Planning Commission Staff Report

July 6, 2017

Case No	16ZONE1060
Request	R-4 to C-2 with waivers and a variance
Project Name	Vega Auto Repair & Sales
Location	4933 Poplar level Road
Owner	Luis Vega
Applicant	Luis Vega
Representative	Concepts 21
Project Area/Size	0.93 acres/40,690 sq ft
Jurisdiction	Louisville Metro
Council District	2 – Barbara Shanklin
Case Manager	Beth Jones, AICP, Planner II

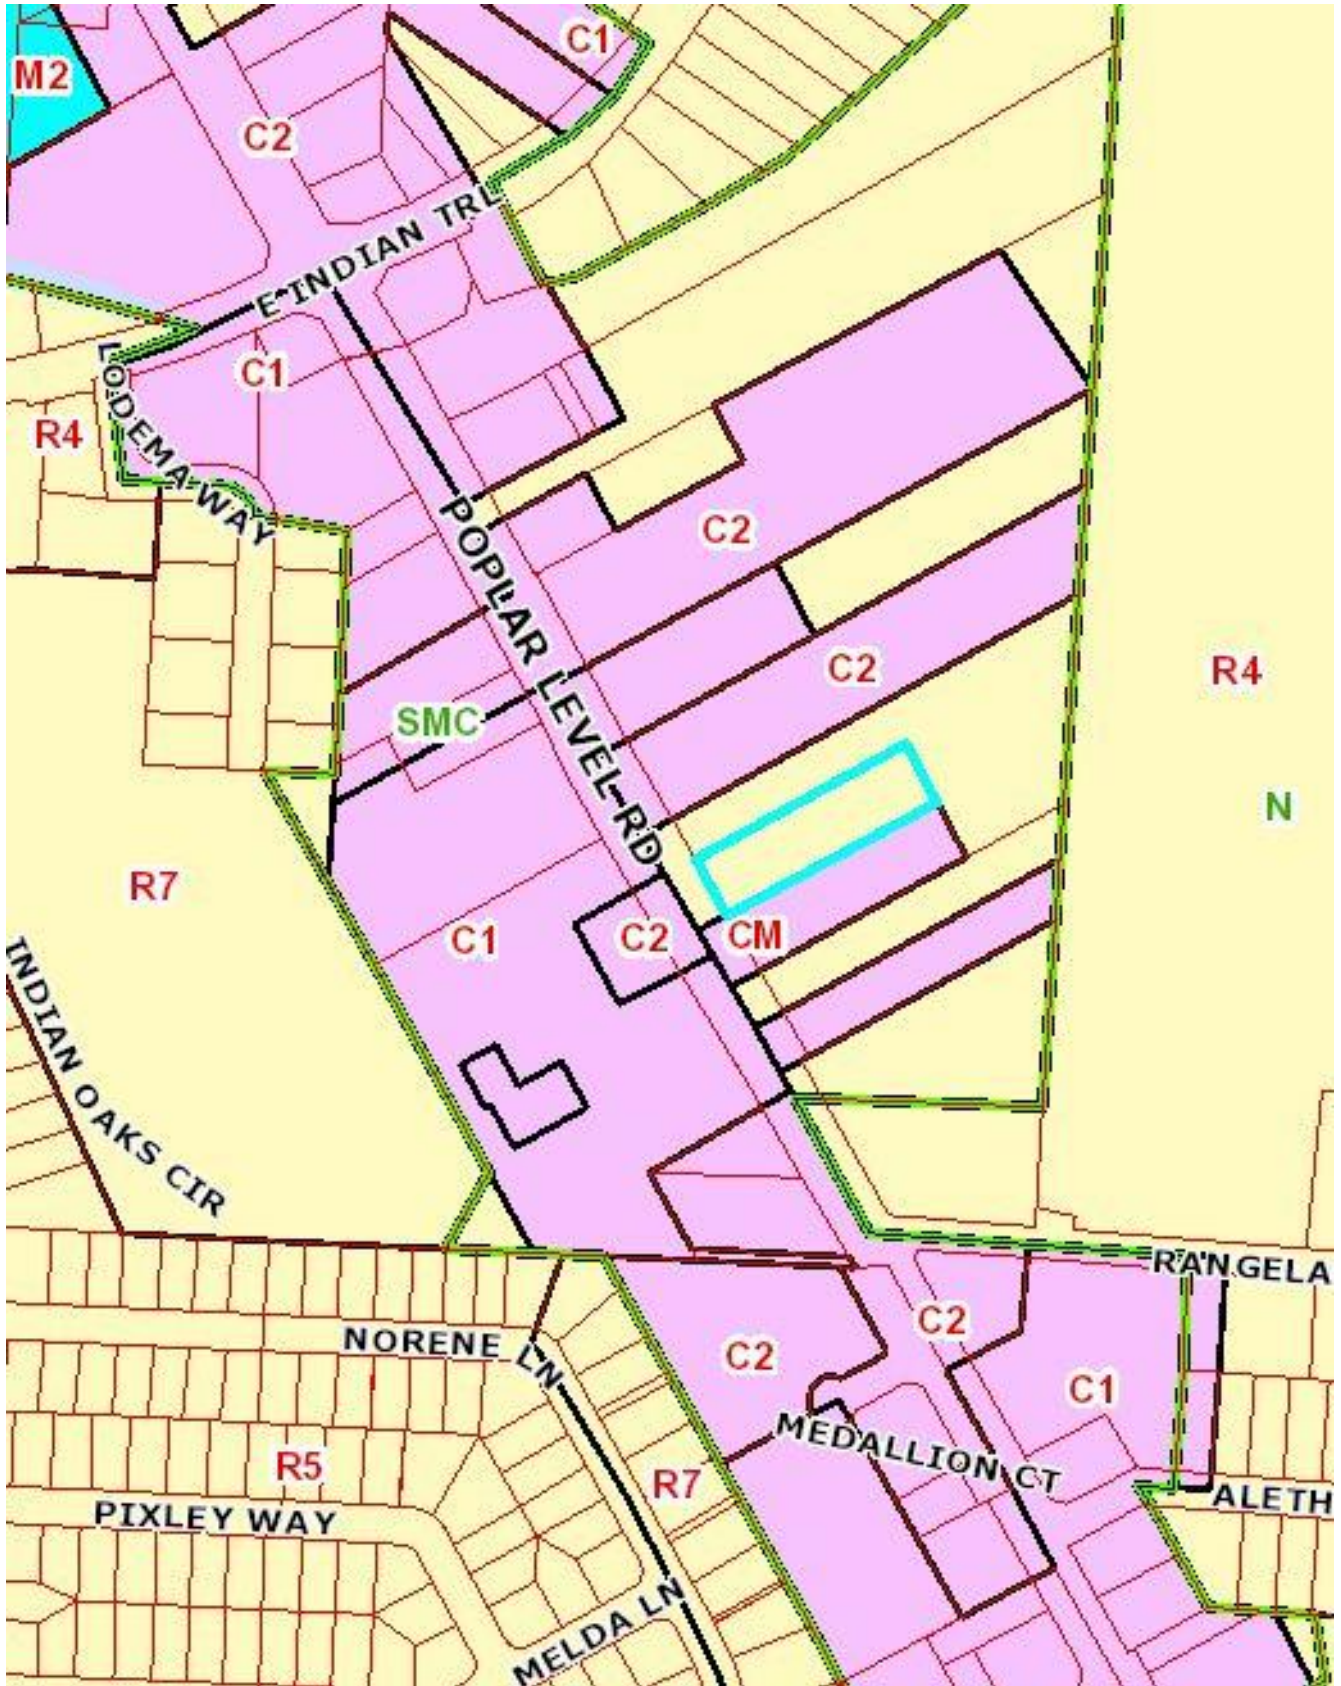
STAFF: These landscape areas are required specifically due to a shared property line with a flag parcel zoned for residential use. The specific portion of the shared property line affected by the requested waivers is along the narrow “pole” portion of the adjoining lot, where future residential development would not be likely. Adjacent to the “flag” area of the adjoining parcel, where future residential development would more likely be located, the proposal retains an existing tree canopy far in excess of buffering requirements. In addition, approximately 80% of the parking associated with the proposal is located within or behind the building, where it would be also be buffered from residential uses by the tree canopy.

STAFF: 24 of the 33 parking spaces provided are located within or behind the proposed building, adjacent to an existing tree canopy area of 29,152 sq ft. which would serve as a buffer to any future residential uses on the adjacent R-4 parcel. The width of the parcel can only accommodate 7 parking spaces along the street frontage which, if considered separately, would have no ILA requirement.

STAFF: The requested variance will affect only the adjoining undeveloped property and only in a specific area of the property that is unlikely to be developed for residential uses due to its flag lot configuration. There are no health or safety impacts associated with the variance.

STAFF: The requested variance arises from the residential zoning and the unusual configuration of an adjoining property. The 25 ft. side yard is required due to its residential zoning, but its configuration makes it unlikely that that the specific area of the variance request would be developed for residential

STAFF: Due to the narrow width of the parcel, strict application of the regulation would not permit the applicant to construct a functional building and also provide for circulation lane to the rear of the property for the necessary employee and customer parking.
